First Judicial District of Pennsylvania's ("FJD")

**Operation, Maintenance & Support Services
(OM&S)**

VENDORS' QUESTIONS AND ANSWERS ("Q&A")

PHILADELPHIA FAMILY COURT BUILDING
1501 ARCH STREET
PHILADELPHIA, PENNSYLVANIA

DRAWING TITLE: SITE PLAN

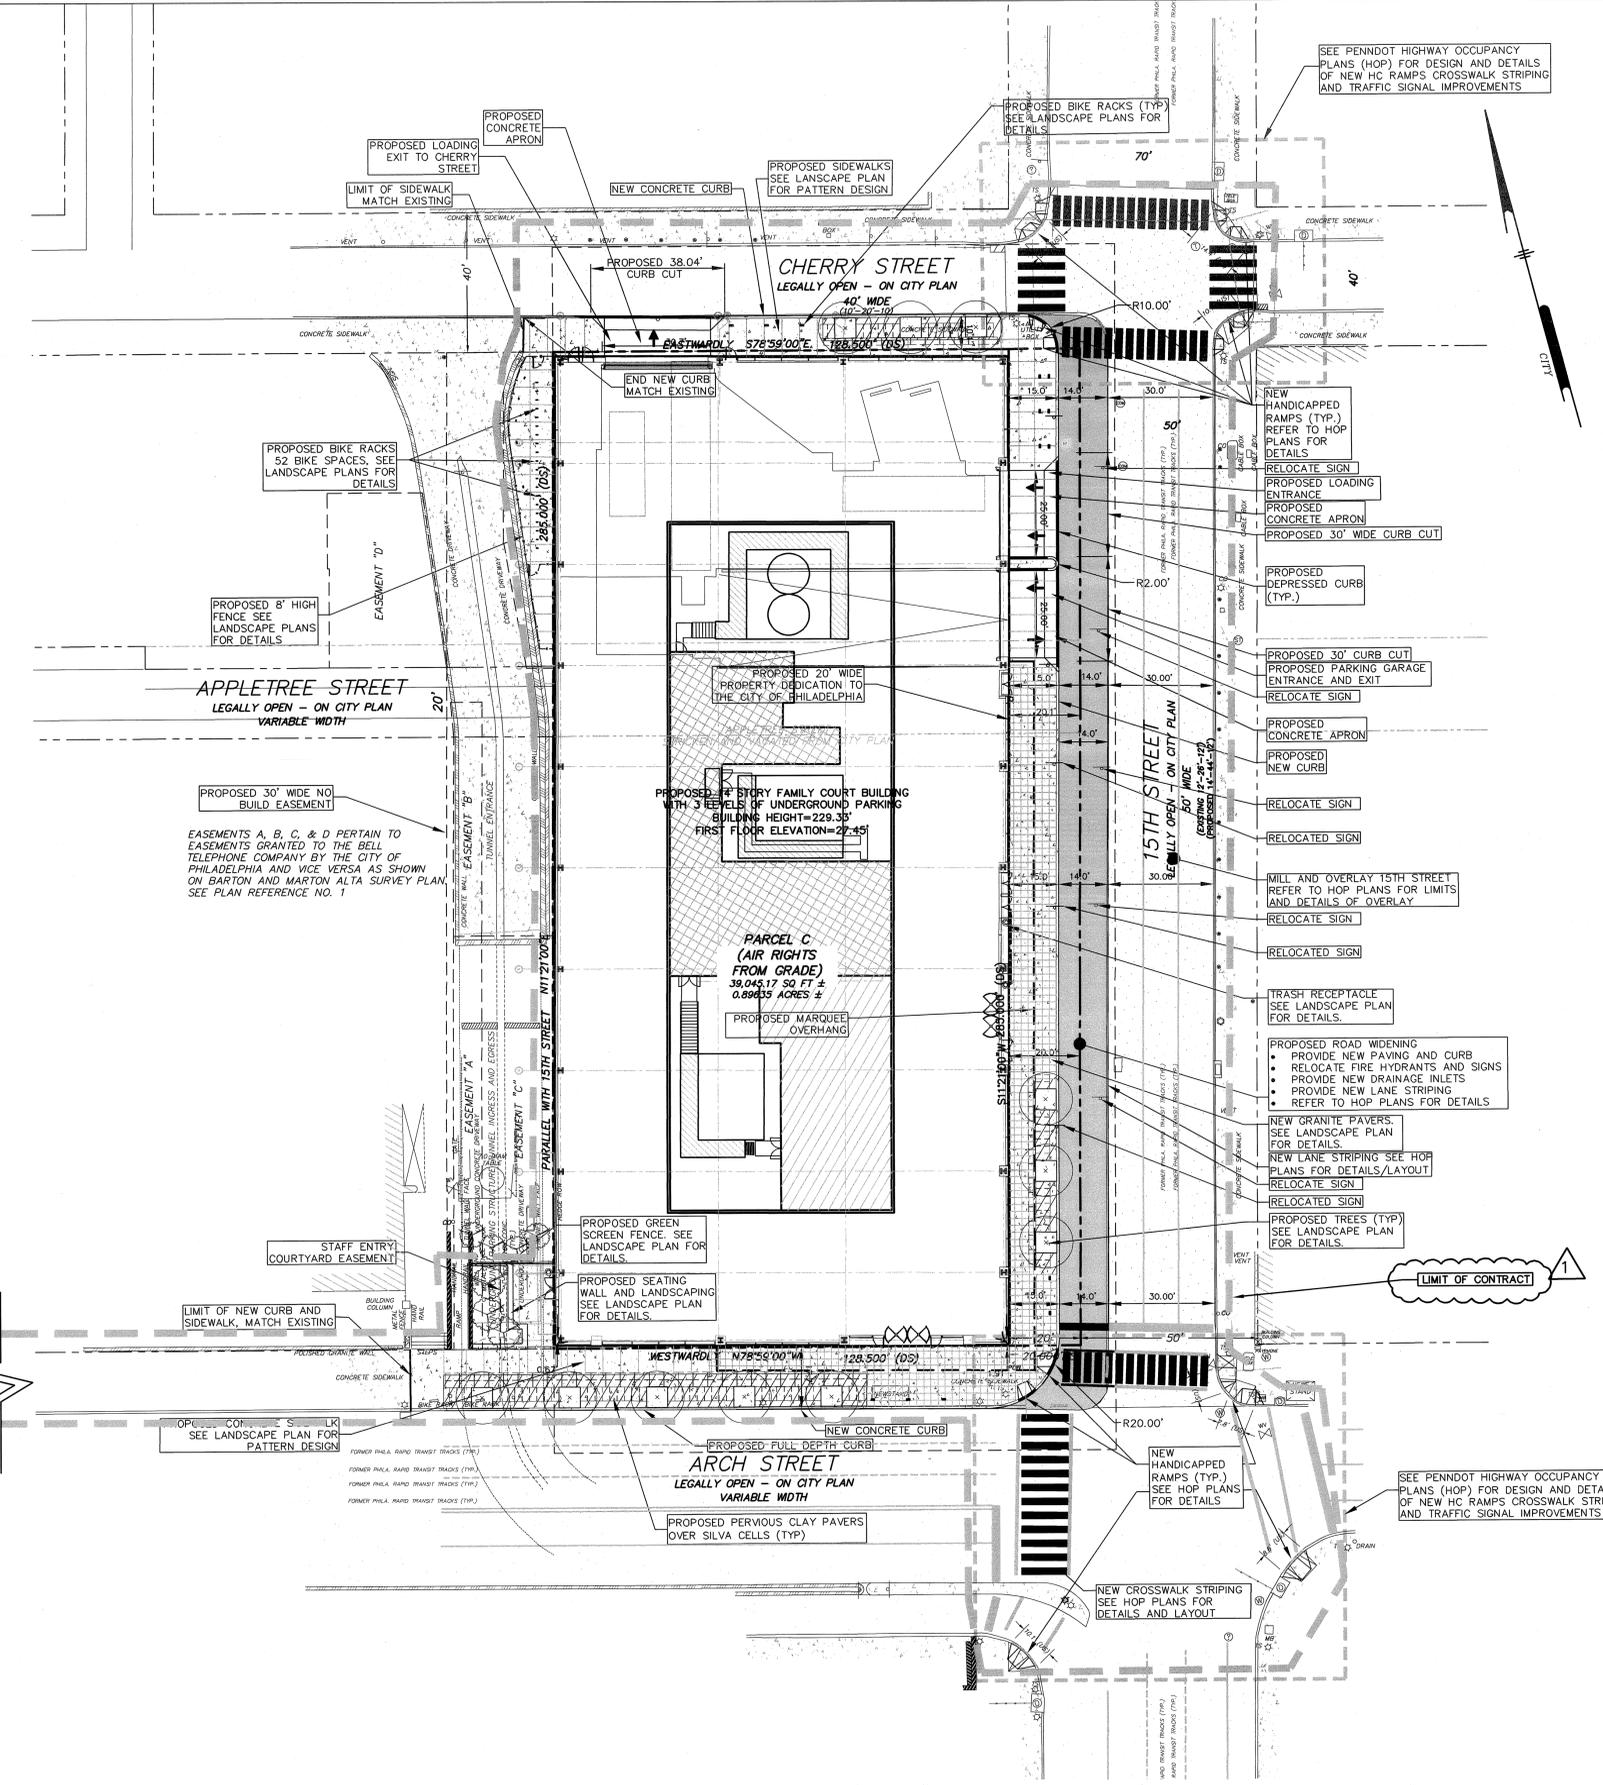
- Q41. Can the FJD provide a copy of the site plan in order to accurately price landscaping services?**
Drawings are available electronically. Forward email and contact info and the site for downloading documents will be forwarded.
